**TOWN OF MOUNTAIN VILLAGE
REGULAR DESIGN REVIEW BOARD MEETING AGENDA
THURSDAY MARCH 30, 2023 10:00 AM
MOUNTAIN VILLAGE TOWN HALL
455 MOUNTAIN VILLAGE BLVD, MOUNTAIN VILLAGE, COLORADO
TO BE HELD HYBRID THROUGH ZOOM:**

**DESIGN REVIEW BOARD MINUTES
TOWN OF MOUNTAIN VILLAGE
REGULAR DESIGN REVIEW BOARD MEETING
MARCH 2, 2023**

C2.2

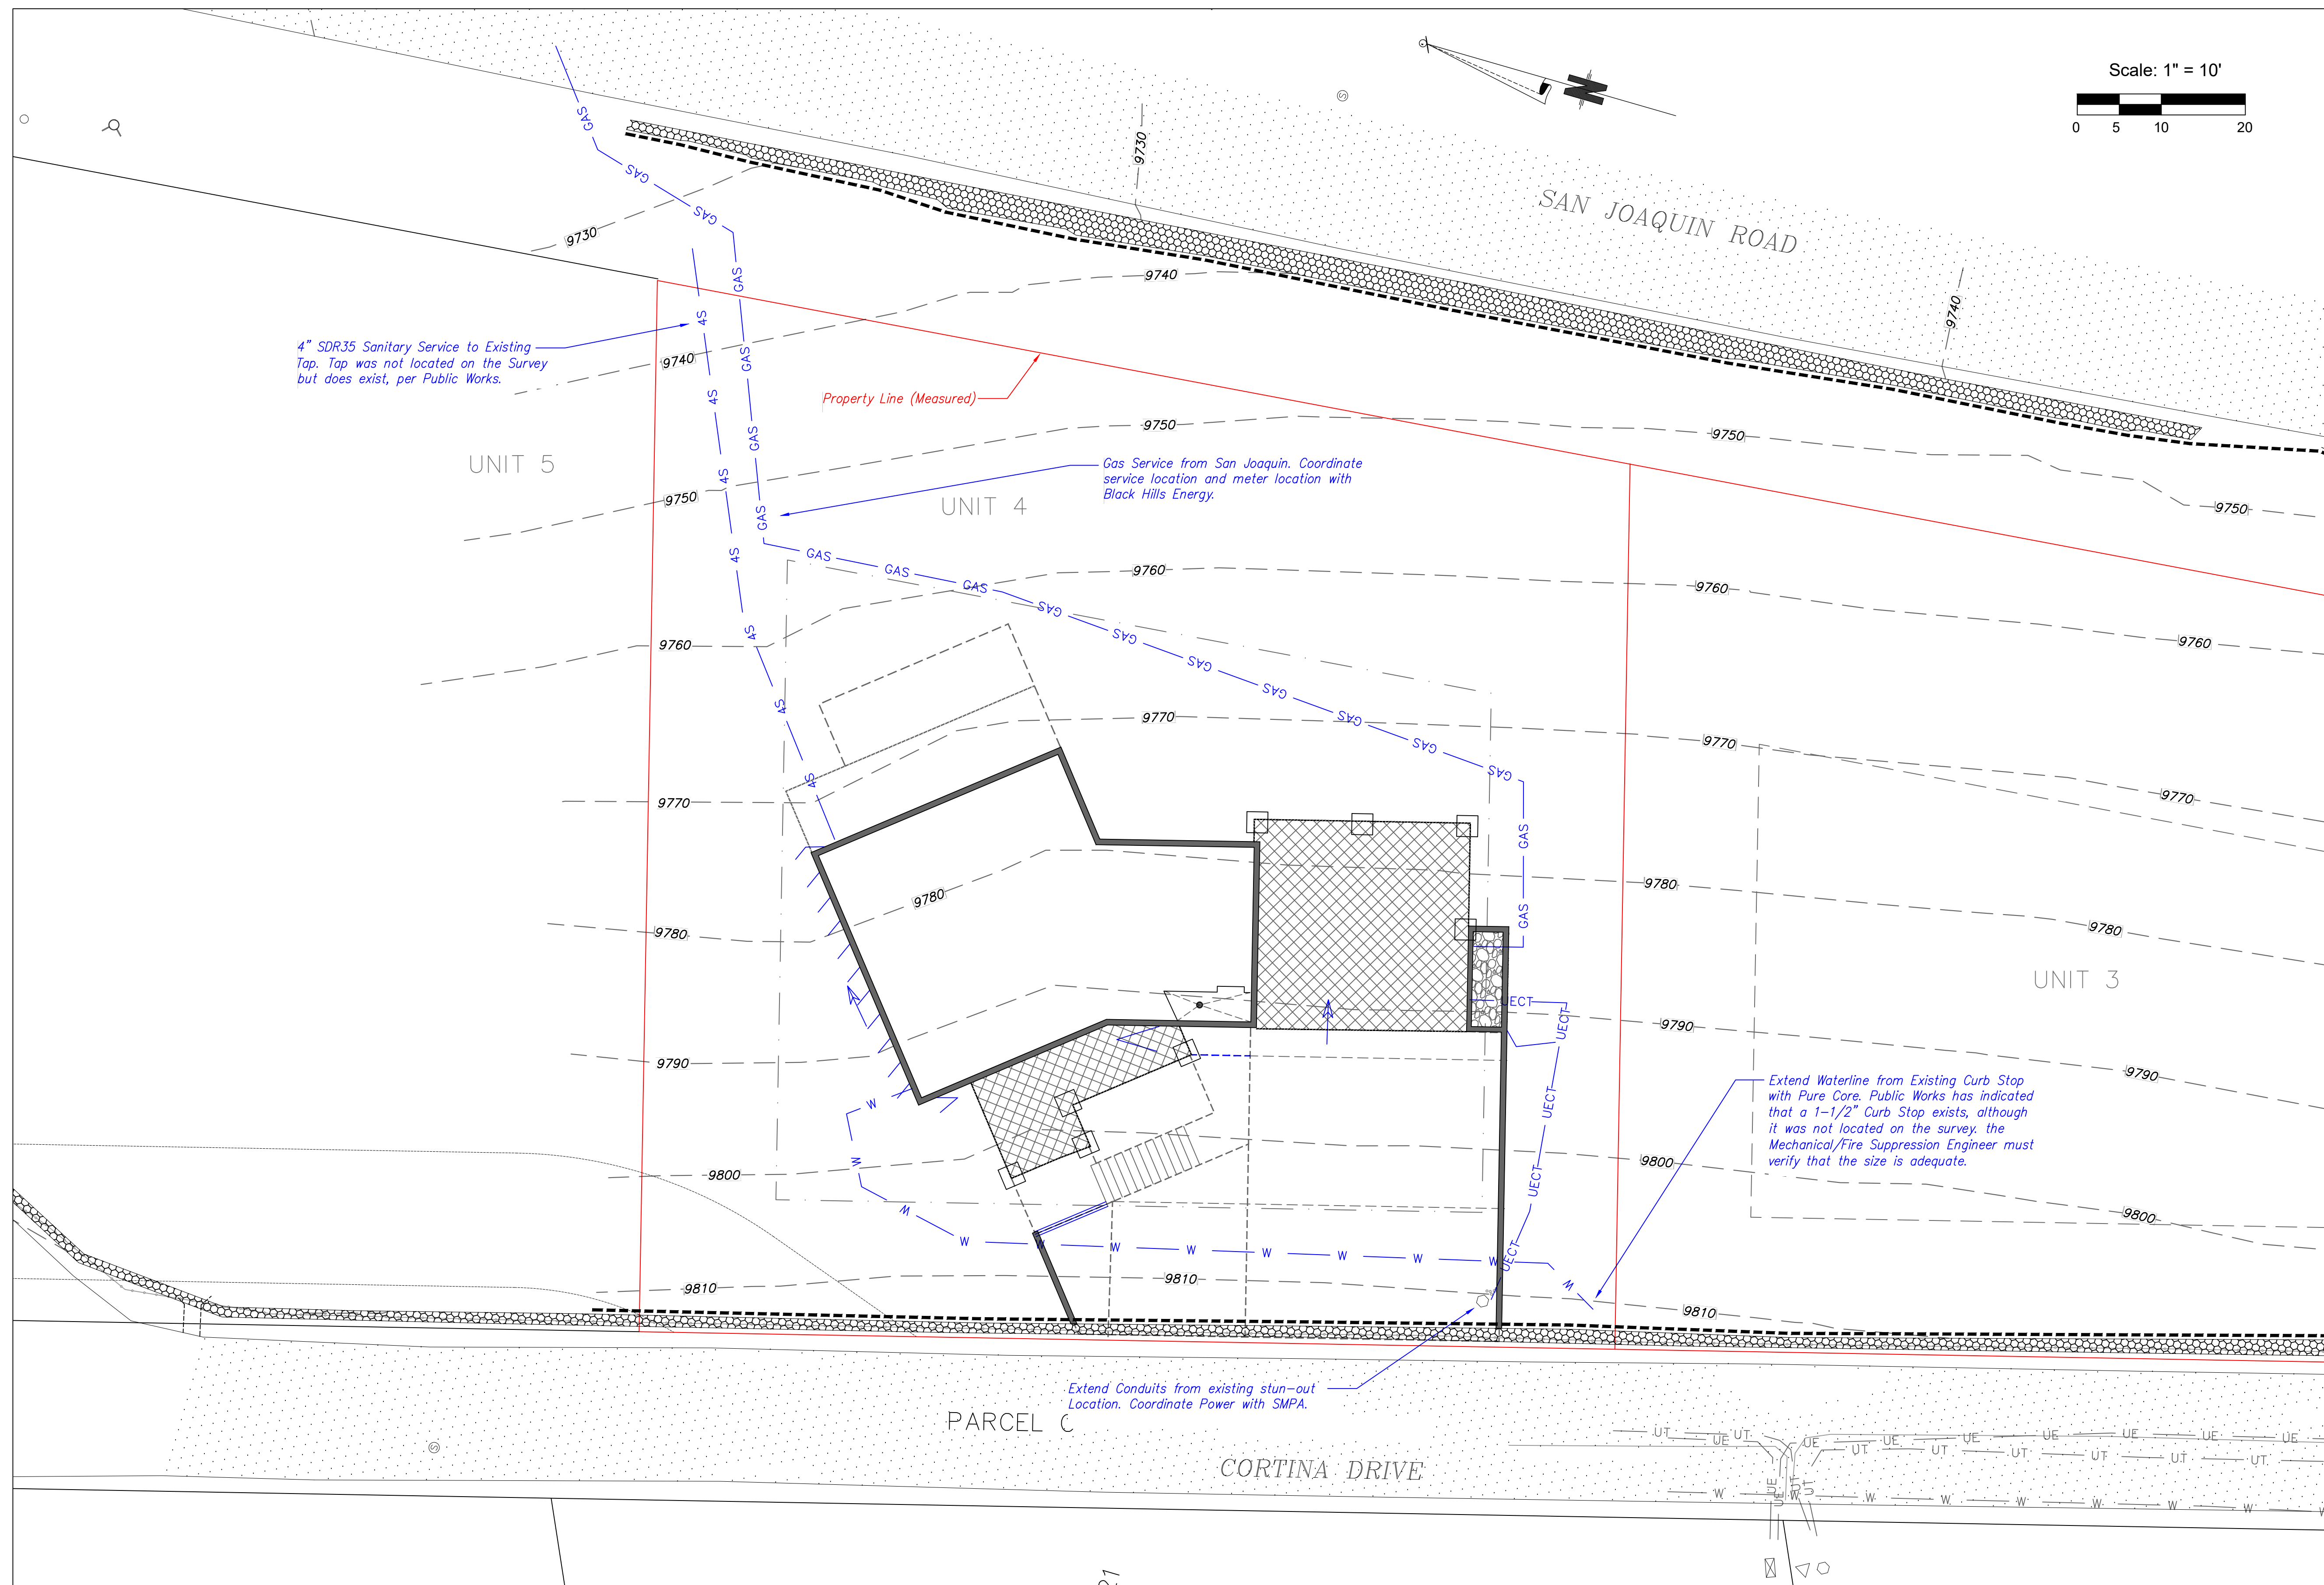
Sheet C2.2 shows the driveway profile for the proposed structure. The driveway is made of concrete and extends off of Cortina Drive to connect to the garage and entryway off of the mud room level. The bridge is supported by stone veneer walls that connect to the natural grade of the structure and extended into the setback. The proposed driveway has a maximum grade of 6.79 percent and is within the allowed 8 percent maximum grade requirement.

C5

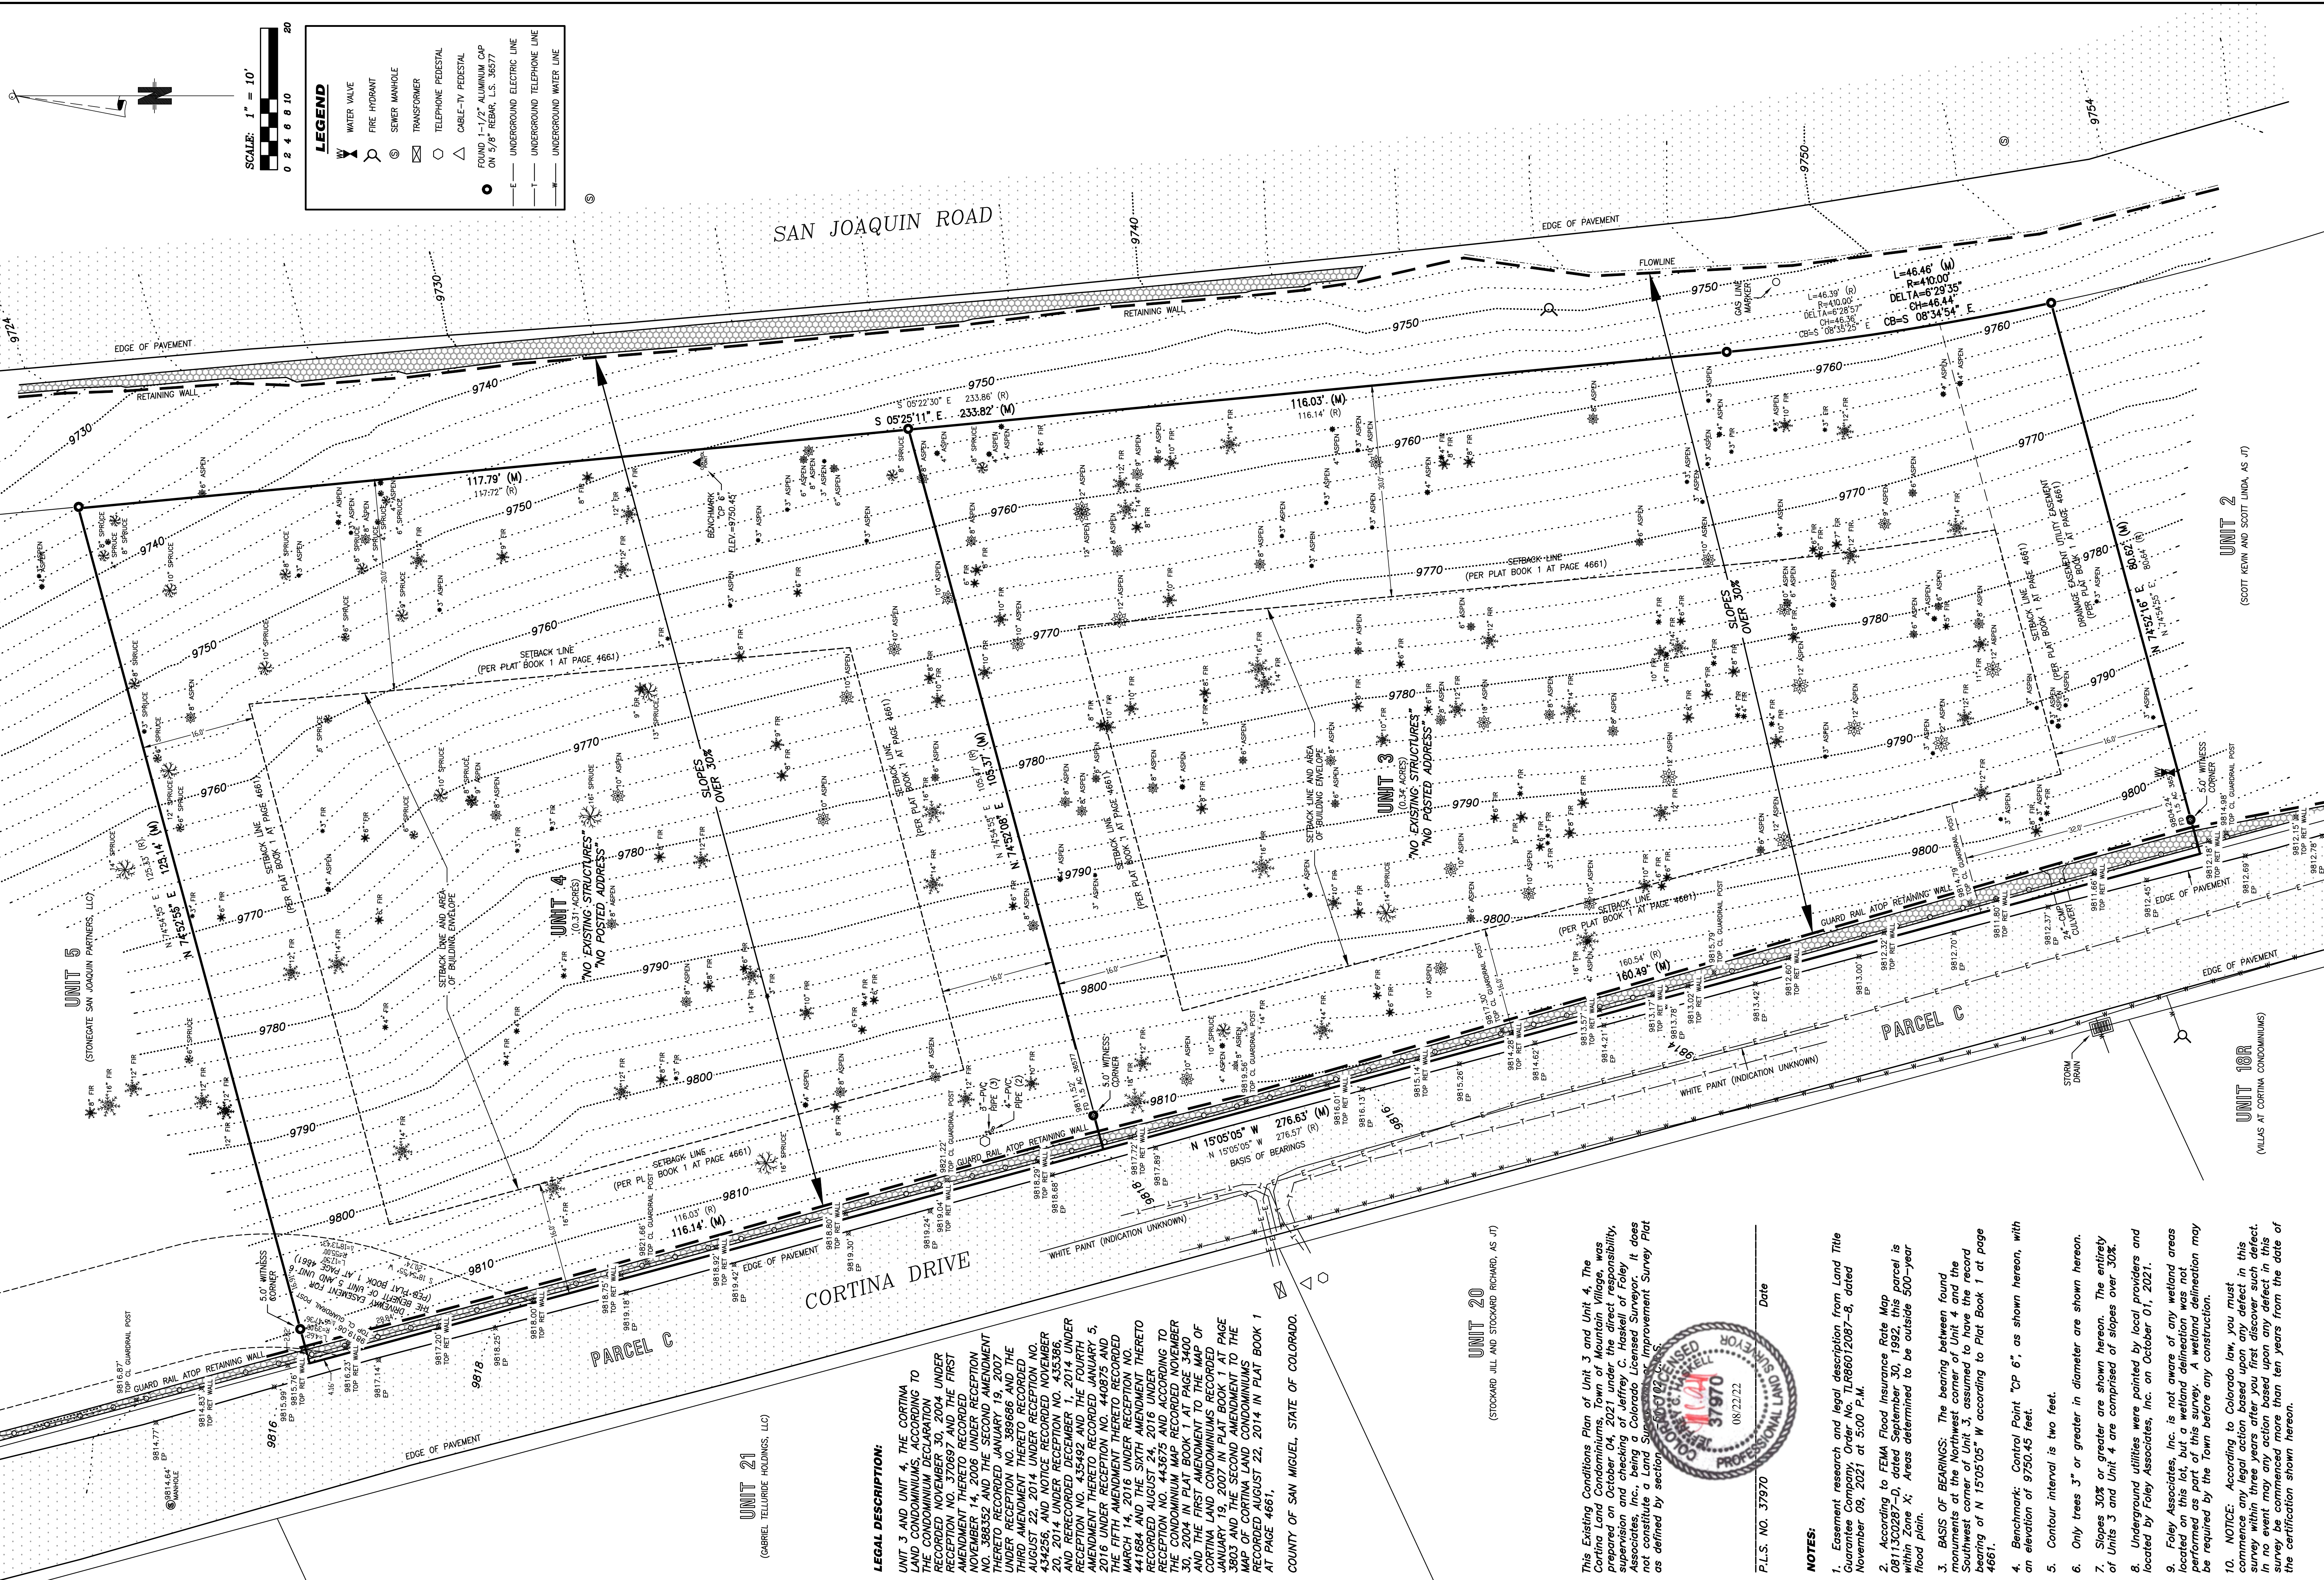
Staff: The applicant has provided a fire mitigation plan on sheets C5 and A1.3. As mentioned, the plan indicates the removal of all existing vegetation within the 15-foot Zone 1 fire mitigation area. The applicant indicates Zone 2 as the area between Zone 1 and the property line due to the size of the lot. The applicant has not indicated the required 10' crown-to-crown separation in Zone 2. Per section 17.6.1A-3d of the CDC, all trees within Zone 2 must have all branches pruned to a height of 10'. It is the responsibility of the lot owner to maintain these regulations required by the wildfire mitigation plan of section 17.6.1A3. Comments provided by the Town Forrester during initial review still apply.

Town Forrester IASR Comment: Due the steepness of the slope the entire lot falls within the Zone 1 or Zone 2 fire mitigation areas, the plan must state that all Zone 2 trees must have a minimum crown separation of 10 feet in between crowns and all shrubs over 10 feet tall must have a minimum crown spacing of 10 feet (see forester comments, Sheets A1.3 & A1.4). See Figure 5 for additional Forrester comments. Prior to building permit the applicant shall meet with the Town forrester on site to assure that all Zone 2 regulations are being met as it relates to both existing trees and newly proposed landscaping.
